Notice of Noncompliance (NON) for June 27, 2024, Inspection at the Closed CE Land Landfill, City of Kaukauna, Outagamie County, License No. 0073

CE Land Landfill (Lic. No. 73) June 27, 2024 Inspection Report September 3, 2024

COMPLIANCE MONITORING AND EVALUATION FORM CASE PACKAGE

Photo # 105832 Photo 6 of 30

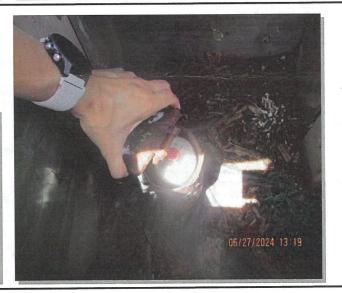
Gas probe GP-5 labeled. Hinge to the lockable cover on the device is rusted through, not allowing the gas probe to be properly locked. The cover on the gas probe needs to be replaced to allow the device to be properly locked.

- b. Gas probe GP-5 was observed to not be lockable due to the hinges on the protective cover rusting through. The lockable cover to gas probe GP-5 needs to either be repaired or replaced, in accordance with s. NR 507.13, Wis. Adm. Code. Provide the department photo documentation of the repair or request an alternative timeline for repairs by October 3, 2024.

Photo # 105835 Photo 9 of 30

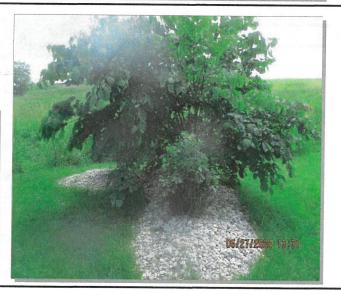
Woody vegetation established near gas probe GP-7. Woody vegetation should be removed if it is on or immediately near the passive gas venting trench to prevent damage to the trench due to the tree roots.
